**PROJECT TITLE**  
LUMO DIGITAL BILLBOARD  
399 LINCOLN ROAD, ADDINGTON  
CHRISTCHURCH

**Reference: Lincoln Road Billboard – CCC RFI**

Christchurch City Council (CCC) has requested some further information in relation to the proposed digital billboard at 399 Lincoln Road. We have reviewed the request and provide the further information below in order to respond to the queries.

Figure 1: Pole 6 Red Aspect Projection

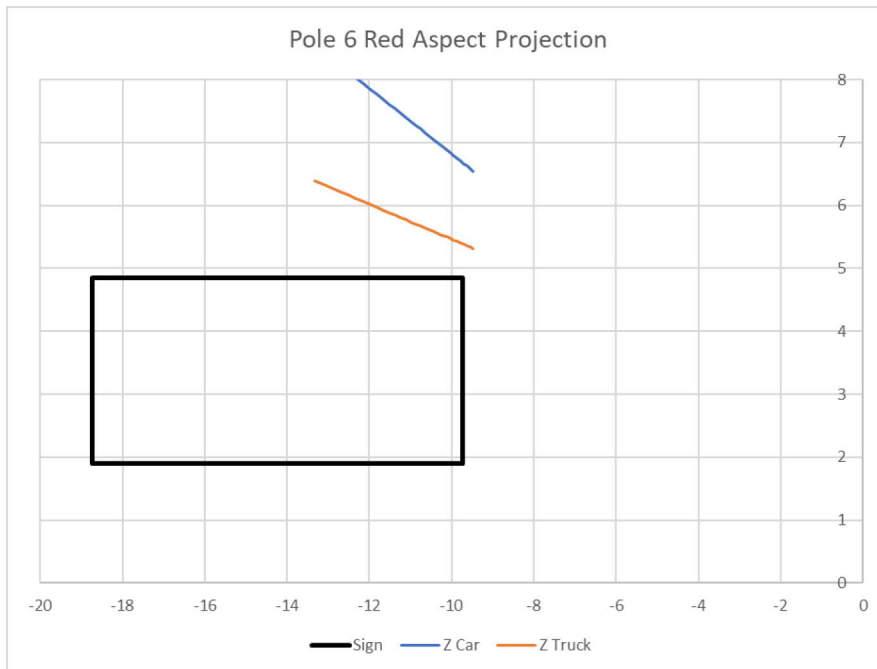
Figures 1 to 6 show how the projected position of the red and green aspects for poles 6, 7 and 10 will change with respect to billboard as drivers traverse the decision zone. In each case, the lower right of the projected lines corresponds with the entry point to the decision zone.

For Pole 6, the projection indicates that the signal aspects will be clear of the billboard at all times from the position of a car driver. For a truck driver, the projected position of the aspect will track across the corner of the billboard. However, given that the surrounding backing board is black, the visibility of the aspect is unlikely to be confused with the content of the billboard.

Figure 3: Pole 7 Red Aspect Projection

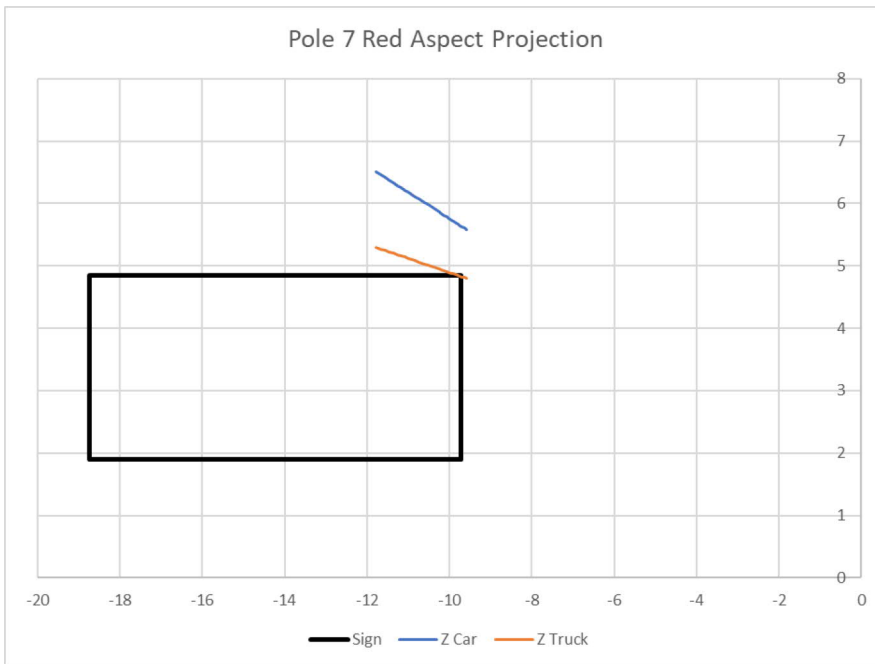
Visibility to Signal Pole 7 is largely obstructed by signal pole 6 until vehicles are approaching the end of the decision zone. The analysis of the projected positions with respect to the billboard indicate that the red aspect will always be visible above the billboard even for truck drivers. While the green aspect will also appear above the billboard to car drivers, the projected position will track across the upper corner of the billboard from a truck driver position. As with Pole 6, since the surrounding backing board is black, the visibility of the aspect is unlikely to be confused with the content of the billboard.

Figure 5: Pole 10 Red Aspect Projection

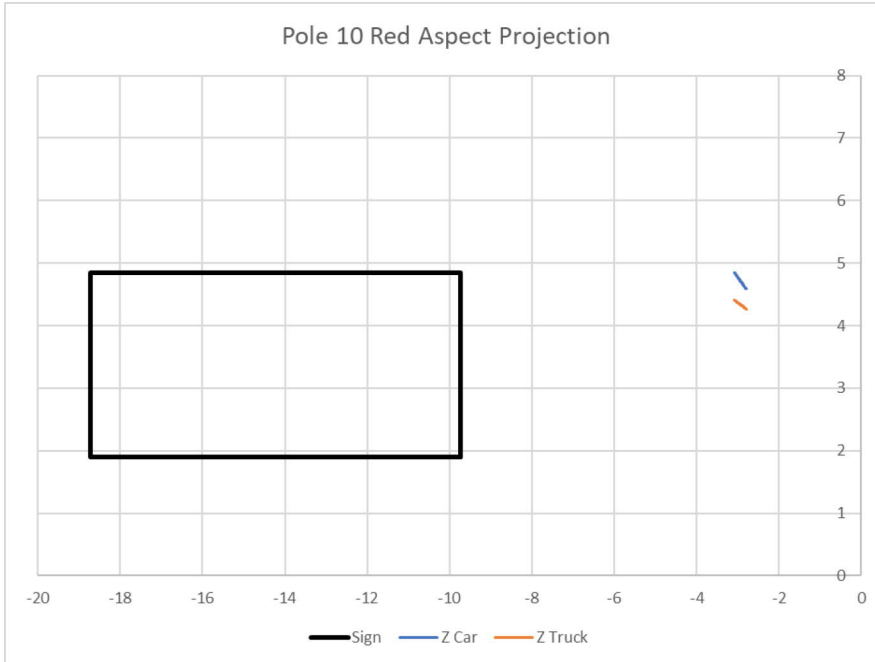
There are no conflicts with pole 10 at any point as vehicles traverse the decision zone.

**GROVE RD / HAGLEY AVE / LINCOLN RD / MOOREHOUSE AVE  
BILLBOARD SIGHTLINES**

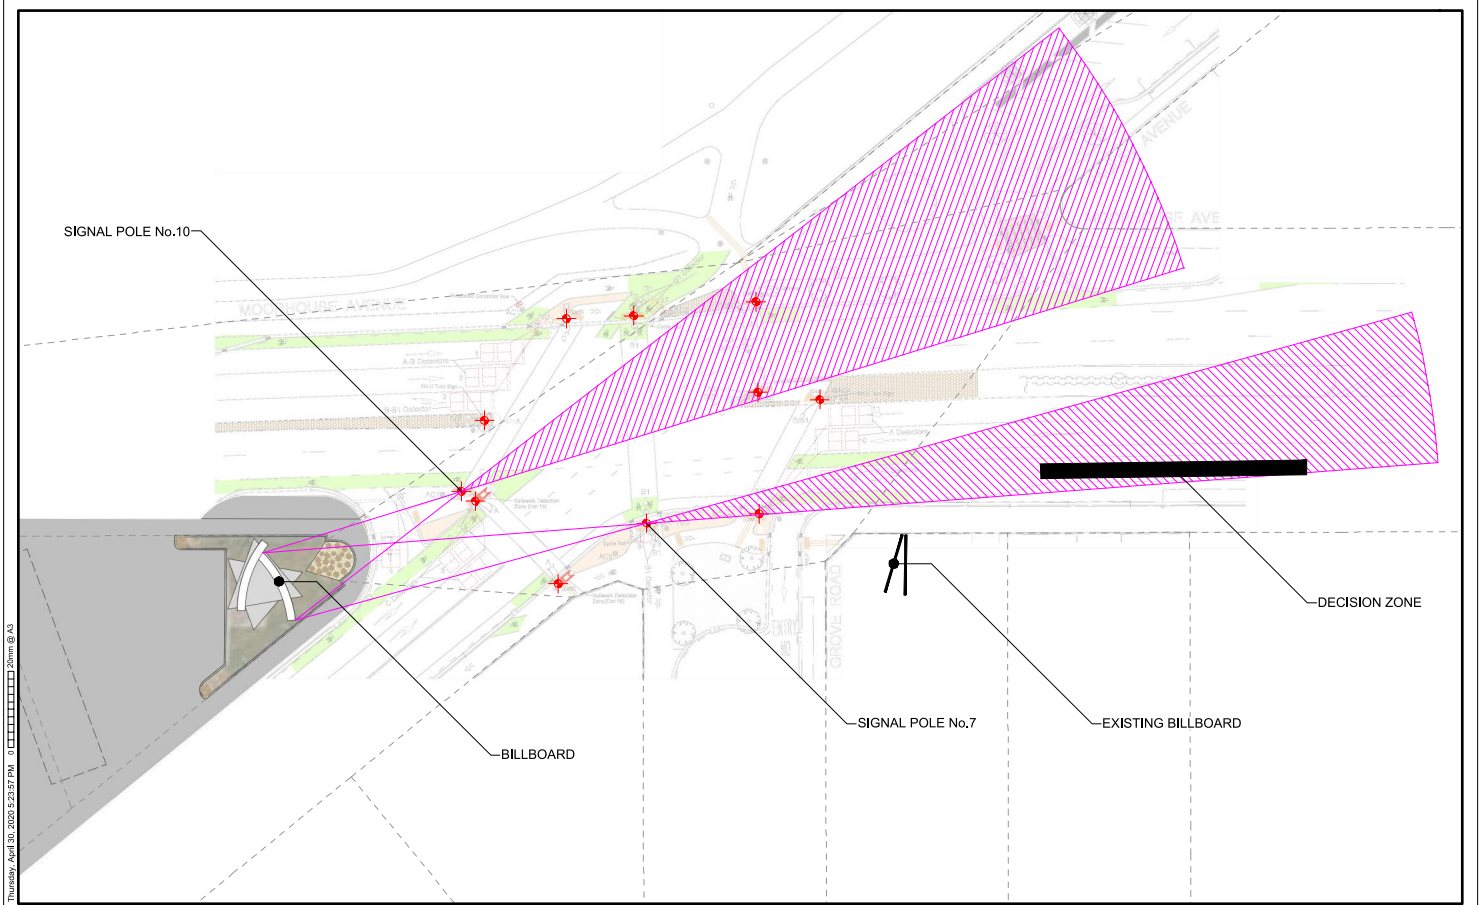
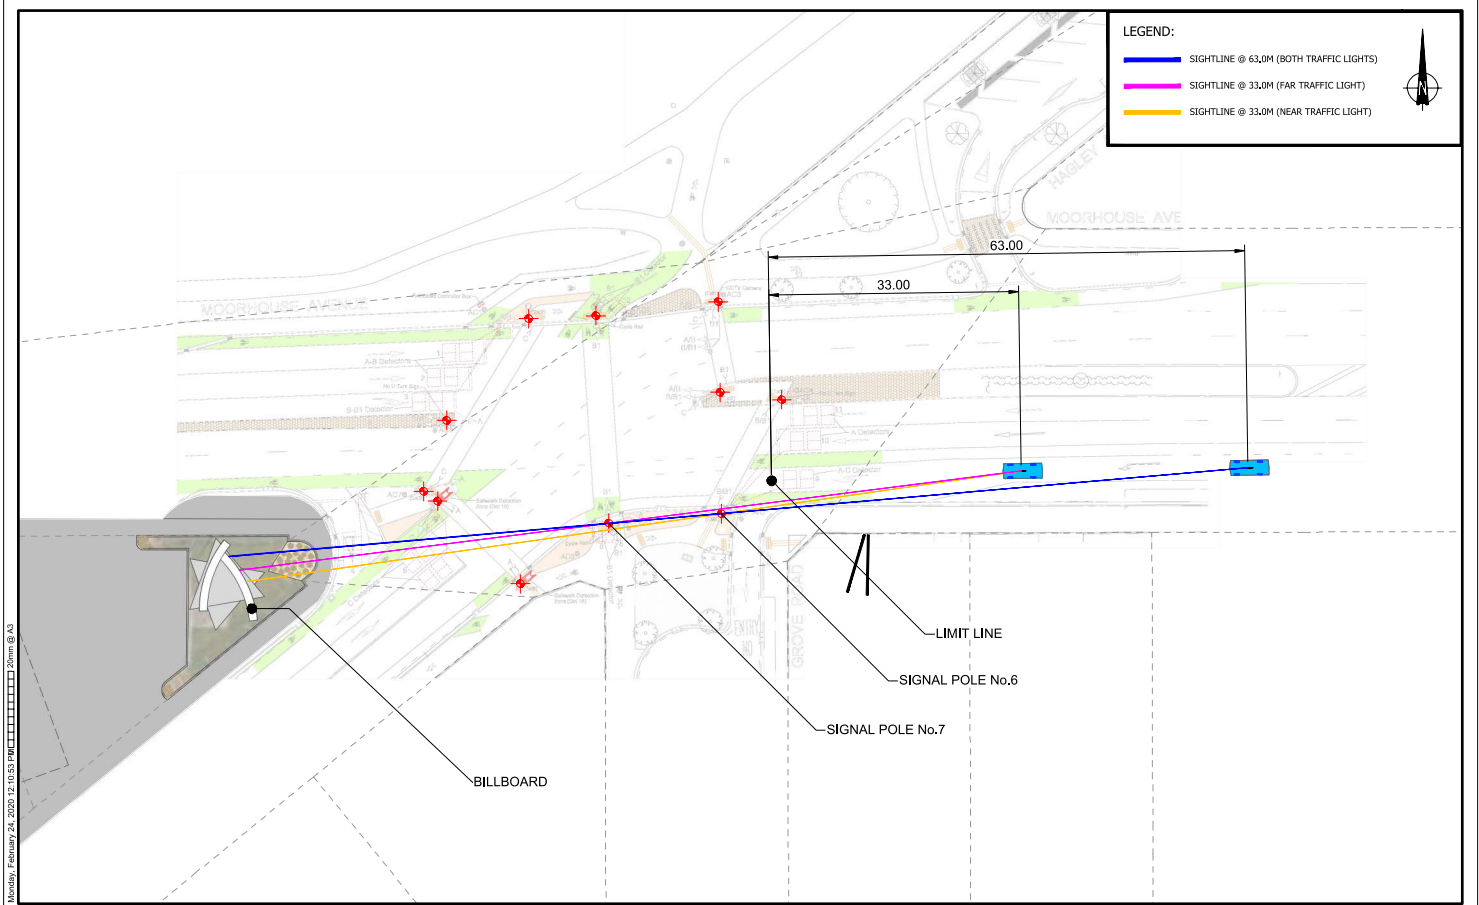
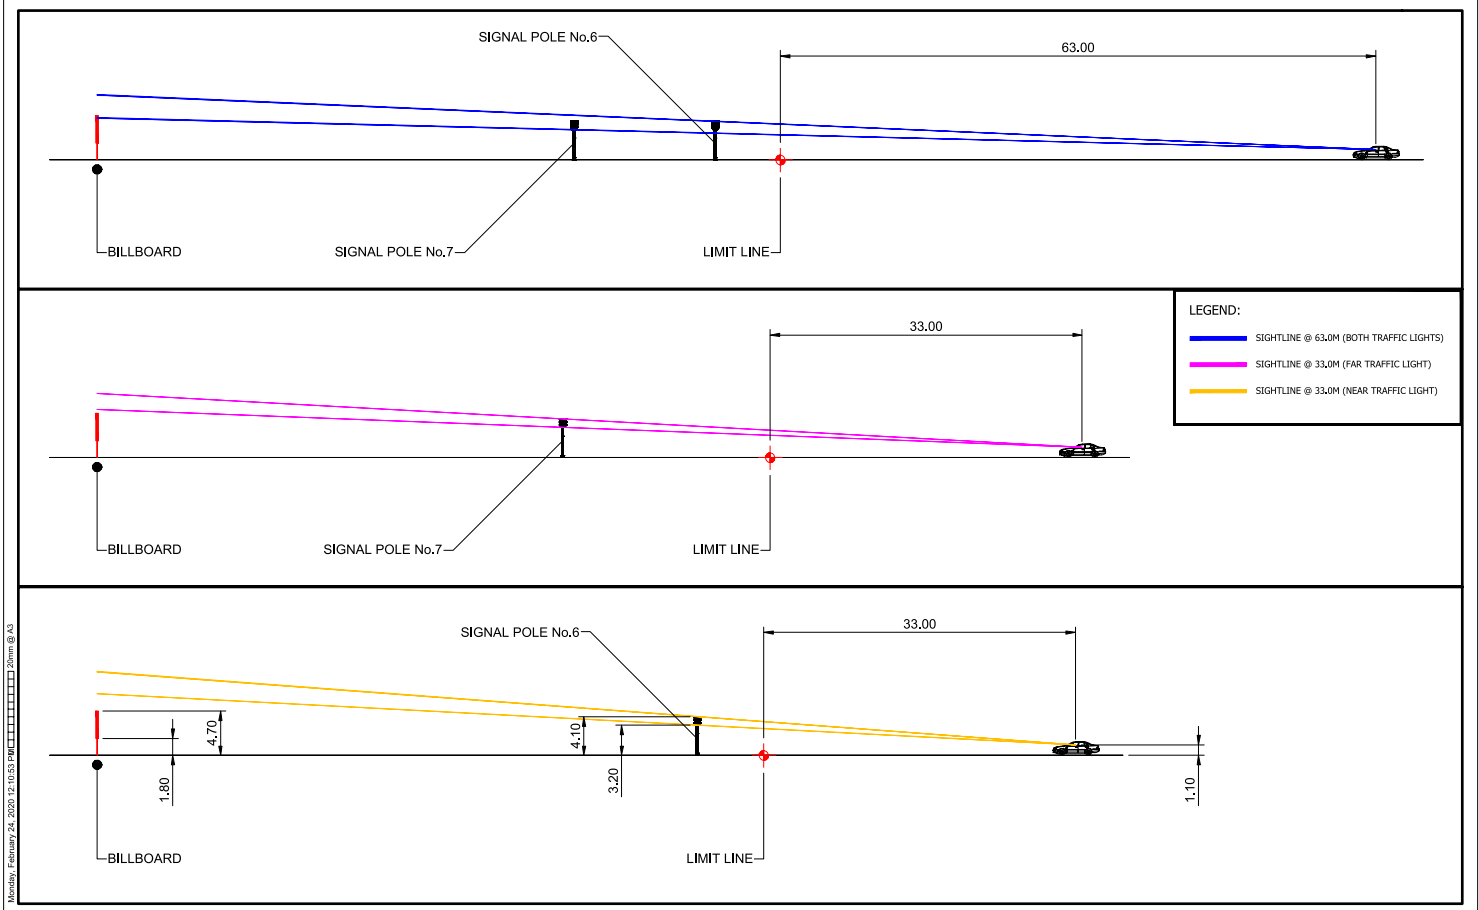
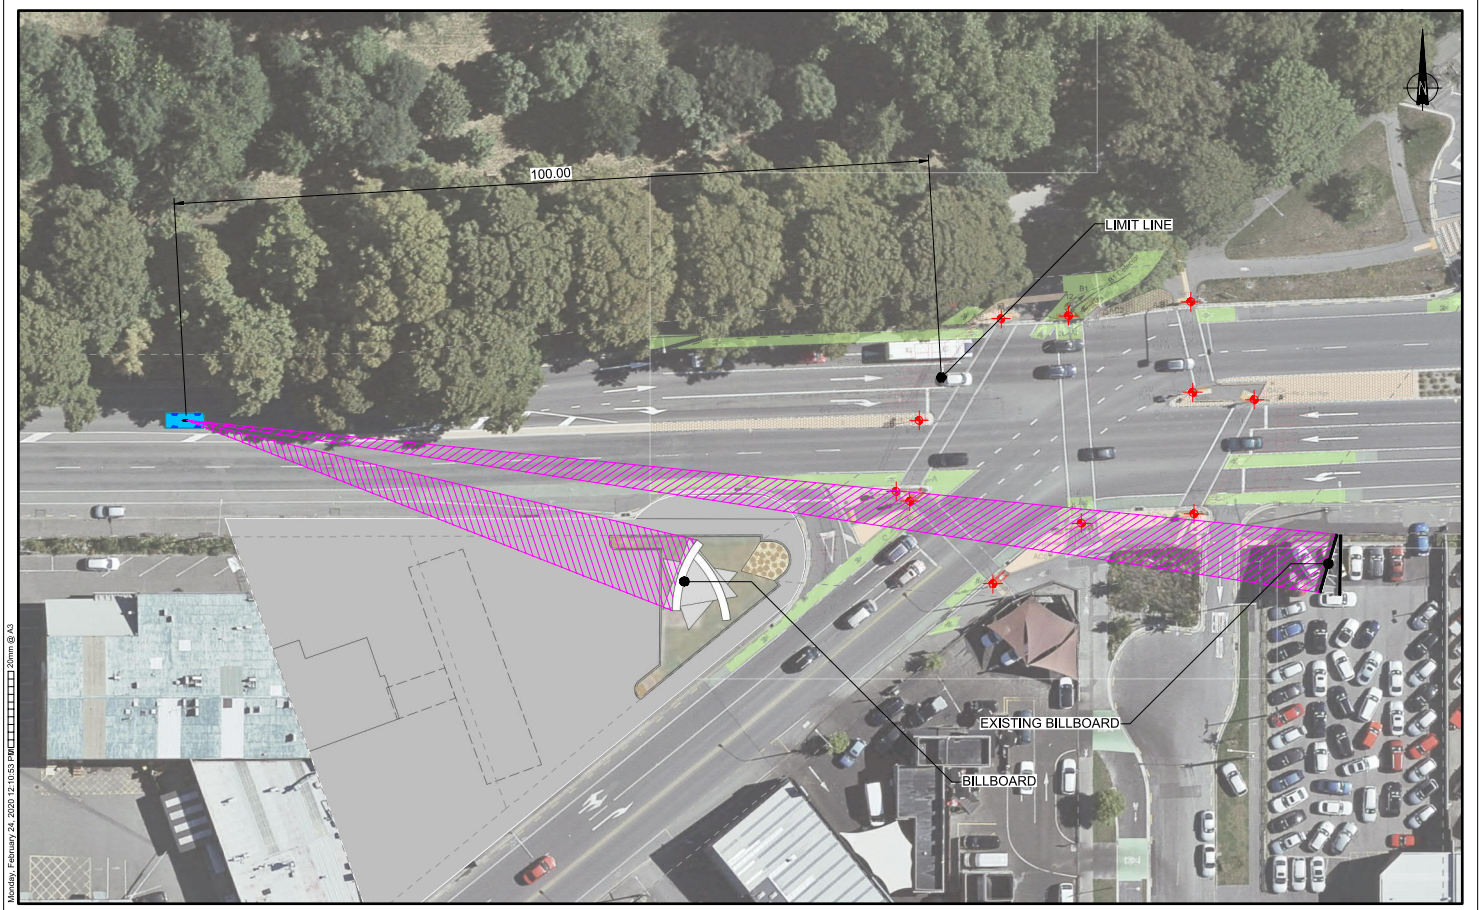
The attached drawing set has extended to include a drawing that shows the requested sightlines for the typical eye height of a truck driver, 2.4m. With the higher eye height compared with car drivers, the signal aspects at pole 6 and pole 7 will appear at a similar height to the upper parts of the billboard as vehicles approach the limit line. Since this figure does not show the lateral positions of the poles with respect to the billboard, additional analysis has been undertaken to investigate how the projected position of the signal aspects for car drivers and truck drivers would change with respect to the billboard as vehicles travel through the decision zone.
